Point Beach Nuclear Plant, Units 1 and 2
Dockets 50-266 and 50-301
Renewed License Nos. DPR-24 and DPR-27

Response (90 Day) to Request for Additional Information
License Amendment Request Associated with NFPA 805

RESPONSE (90 DAY) TO REQUEST FOR ADDITIONAL INFORMATION LICENSE AMENDMENT REQUEST ASSOCIATED WITH NFPA 805

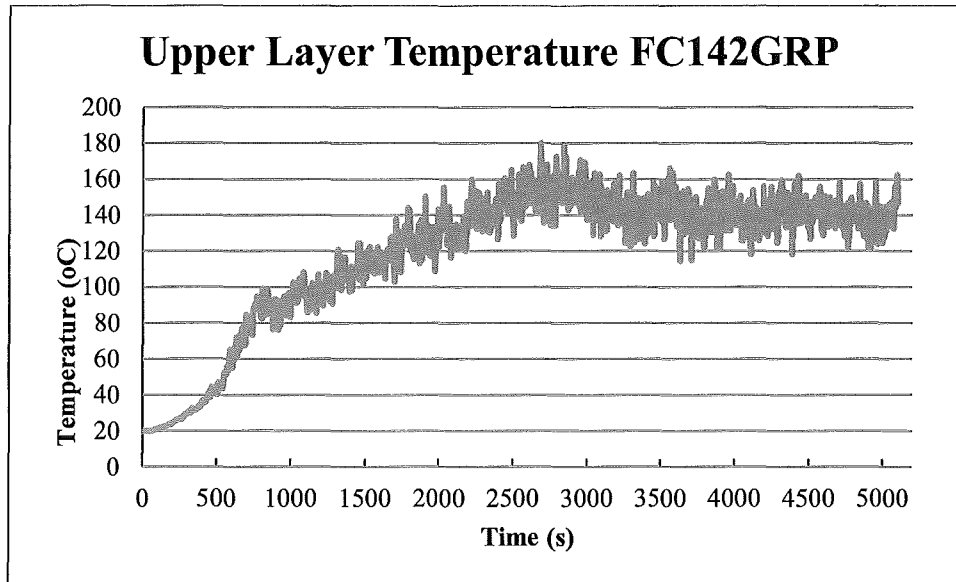
- iii. *Explain how the size of the vents in the exposing compartments used in the MQH HGL calculations was determined, and up to what extent these vent sizes are representative of conditions in the plant; and,*

Fire Compartment 142GRP (CCW Pump Room) has two large open horizontal vents in the ceiling in the form of an open stairwell (13 ft. by 15 ft.) and an open hatchway (12 ft. x 15 ft.), with a total open horizontal vent area of 375 ft². The horizontal vent area was added to the vertical open vent area seven open doorways and miscellaneous open wall penetrations, totaling 345 ft² and modeled as a single vertical vent measuring 30 ft. by 24 ft. (720 ft²). The top of the vent was modeled at ceiling height due to the location of the horizontal vents in the ceiling and the height of the open doorways and penetrations.

In order to demonstrate that this approach is acceptable, FC 142GRP was modeled in FDS using the same dimensions modeled in the DFMWB. Each vent, both vertical and horizontal, was modeled individually instead of combined and the most conservative HRR profile was selected from the DFMWB, including any secondary combustibles. The FDS results for the most conservative HRR profile indicate that the upper gas layer temperature only reaches 180°C, which does not result in the formation of a damaging HGL (205°C). This is consistent with the original DFMWB results and further analysis is not required. FDS was used within the limits of applicability and the analysis was performed within the validated range of NUREG-1824. Refer to the table at the end of this response for evaluation of the relevant normalized parameters. The FDS results are provided in the figure below.

Figure 1: Zone of influence for each Circulating Water Pump

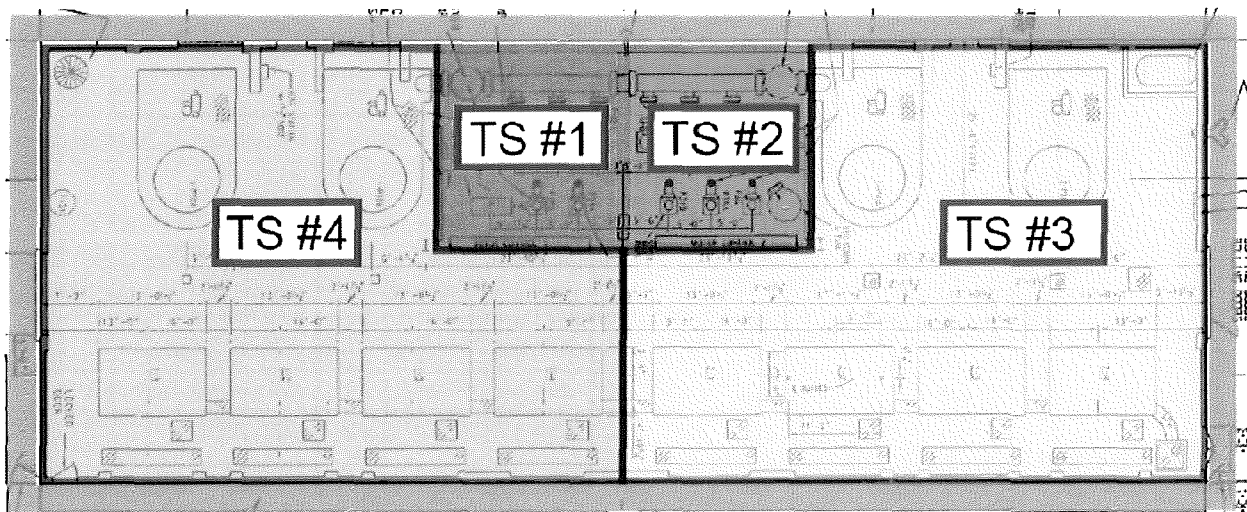
- ii. *Describe in detail how the time to sprinkler activation and the time to heat and smoke detector actuation was calculated.*
- g) *Specifically regarding the CFAST analysis in compartment 552GRP, discuss whether the potential damage was assessed for targets in the lower gas layer (LGL) due to the combined radiant heat flux from the HGL, heated surfaces and the flame. Describe the results of this assessment, and the damage thresholds that were used in this assessment. If a damage assessment based on radiative heat flux (or combined radiative and convective thermal exposure) was not performed, provide technical justification for the assumption that the LGL temperature damage threshold is bounding.*

The CFAST analysis justifies the use of target failure sets limited to those targets within the line of sight of each pump. Although the lower gas layer does not exceed 205°C, FPRA target failures are assumed and accounted for due to direct flame impingement, damaging plume temperatures, radiant heating, and combined thermal exposure impacts. Attachment 1 of Detailed Fire Modeling Report R2168-001-552GRP, details the zone of influence for each pump as well as the damaged FPRA target sets. Therefore, potential damage for targets in the lower gas layer (LGL) due to the combined radiant heat flux from the HGL, heated surfaces, and the flame are addressed by the zone of influence failures in Detailed Fire Modeling Report R2168-001-552GRP.

The zone of influence for each pump is provided in Figure 1, with all targets within TS#4 failing due to a large oil fire at pump 1P-30A or 1P-30B and all targets within TS#3 failing due to a large oil fire at pump 2P-30A or 2P-30B. Target failure was conservatively assumed to fail at time zero.

CFAST was implemented to screen whole room damage via a hot gas layer due to the location of the FPRA targets, all of which are located at or near floor level. The Service Water Pump Room (TS#1 and TS#2 in Figure 1) shields pumps 1P-30A and 1P-30B from the zone of influence of pumps 2P-30A and 2P-30B, and vice

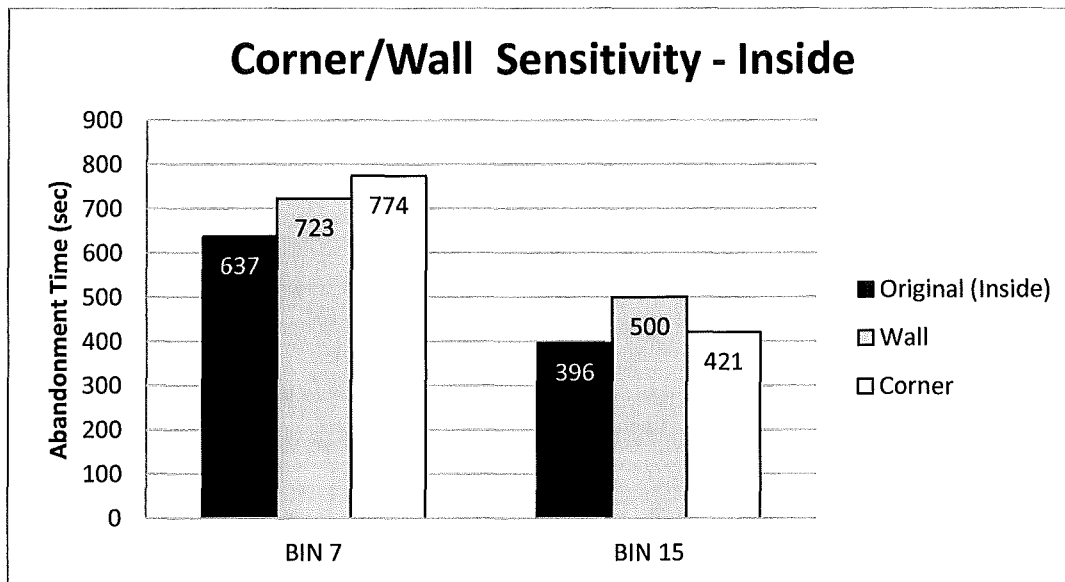
- ii. *FDS simulations were performed with cabinet and transient fires located at four different locations. Describe the technical basis that was used for choosing these locations;*
- iii. *Provide technical justification for assuming that transient fires in the MCR reach peak HRR in 8 min;*

- ii. Two transient and two electrical cabinet scenario locations were postulated for the Main Control Room (MCR) abandonment analysis. The locations of the fires were selected to bound a fire at any location within the room. Each electrical cabinet fire scenario location was conservatively selected such that the fire would spread to two additional cabinets, based on the methodology provided in NUREG/CR-6850, Appendix S, and thereby bound the heat release rate (HRR) of any electrical cabinet scenario. Locations for the transient fires were selected both inside and outside of the horseshoe at locations in close proximity to the main control boards and operators. Devices that measure habitability conditions were located near the fire locations to provide data to conservatively calculate when control room abandonment would be necessary.

The primary goal of the analysis was to determine the effect of the hot gas layer on habitability conditions within the MCR and, therefore, varying the location of the fires modeled in FDS would lead to similar, or potentially less severe, abandonment times. For example, transient scenarios placed farther away from the control boards would have delayed effects on the operators, and single electrical cabinet fires generate less heat and smoke than multi-cabinet fires with much higher heat release rates.
